Response to Comments

Remedial Investigation/Feasibility Study

South State Street Manufactured Gas Plant Site Bellingham, WA

January 2019

Figure 5.1: Disproportionate Cost Analysis Scoring Comparison from South State Street MGP Feasibility Study Report

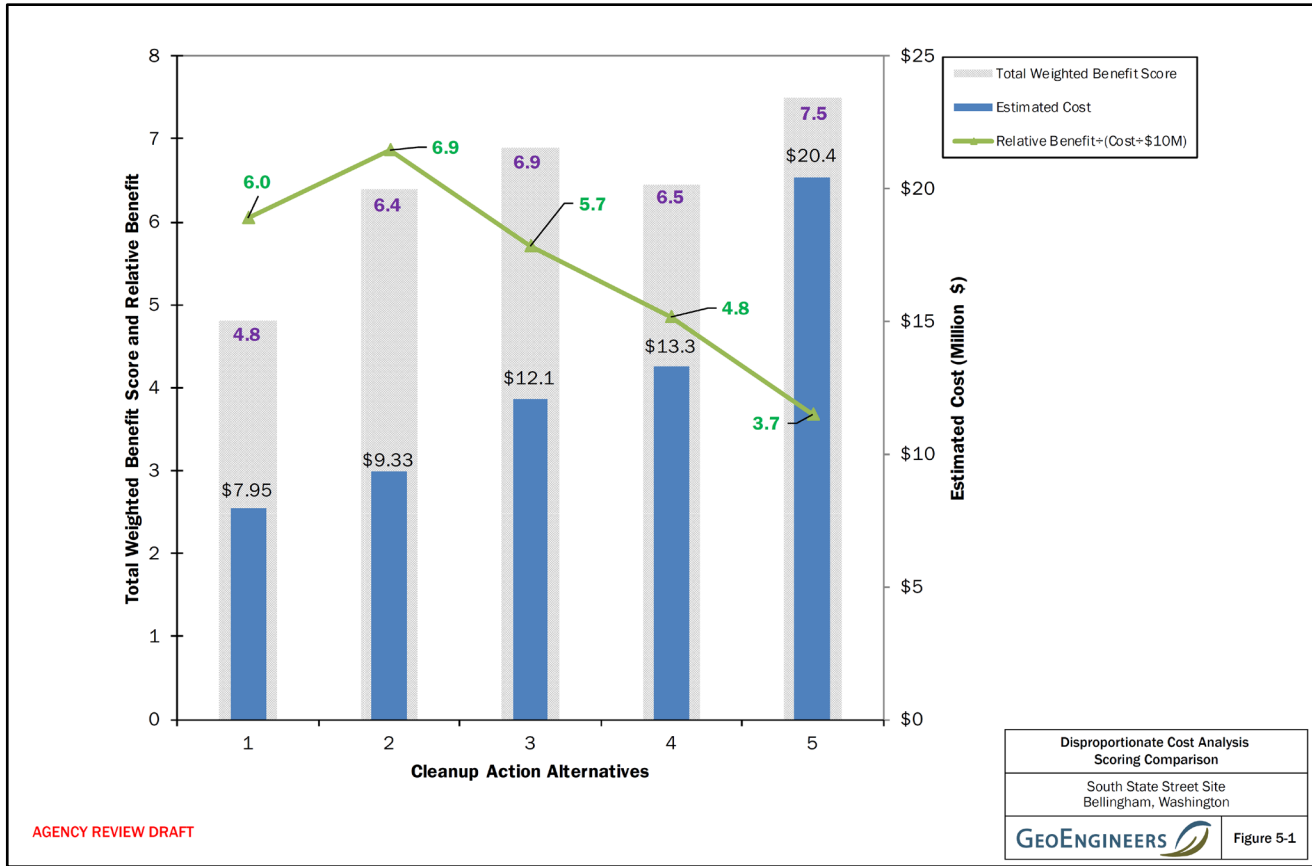
I am a resident of Bellingham and regularly use this trail both for walking and biking. I find that keeping the blackberries on the upland site and fencing this area off is appalling, to say the least. I have picked blackberries here and I don't think they are safe no matter what your indicators are. I feel that they should be removed and either capped, putting large boulders there would protect the public along with a fence. I am finding this site for information very hard to navigate. I was looking for the graphs for the alternatives 1-5 but could not find them. My comment had to do with these graphs but I believe your preferred alternative is #2. I would prefer alternative #3 before #2. I believe the upland cap, the enhanced BIO remediation, monitoring natural attenuation, and institutional control inspections are a necessity. I prefer #3 because soil vapor extraction and in situ solidification are considered. I understand that alternative #5 is too expensive for the level of cleanup and Alternative #1 gives us no protection for the cost. However, for the cost versus cleanup, I do think #3 gives us greater security over #2. I would encourage you to enhance alternative 2 and consider some of the enhancements between 3,4,5 to upgrade alternative #2. Thank you for your reaching out to the public and your very informative public meetings.

We assume the referenced graph is Figure 5-1, Disproportionate Cost Analysis Scoring Comparison (see below). This figure is located in the FS portion of the Draft RI/FS report at: <https://fortress.wa.gov/ecy/gsp/DocViewer.ashx?did=77684>. The FS also contains Tables 3-1 through 5-2 which present the various remediation technology screening, evaluation and ranking processes.

Figure 5-1 graphically depicts a comparison of the costs and environmental benefits of Cleanup Action Alternatives 1 - 5. All of these alternatives protect human health and the environment, and the purpose of the cost/benefit analysis is to identify the alternative that is permanent to the maximum extent practicable. The alternatives evaluated in the FS that cost more than Alternative 2 do not achieve a proportionate increase in benefit for the increase in cost. Therefore, Alternative 2 is revealed as the alternative that has the highest benefit per unit cost, is permanent to the maximum extent practicable and the preferred alternative.
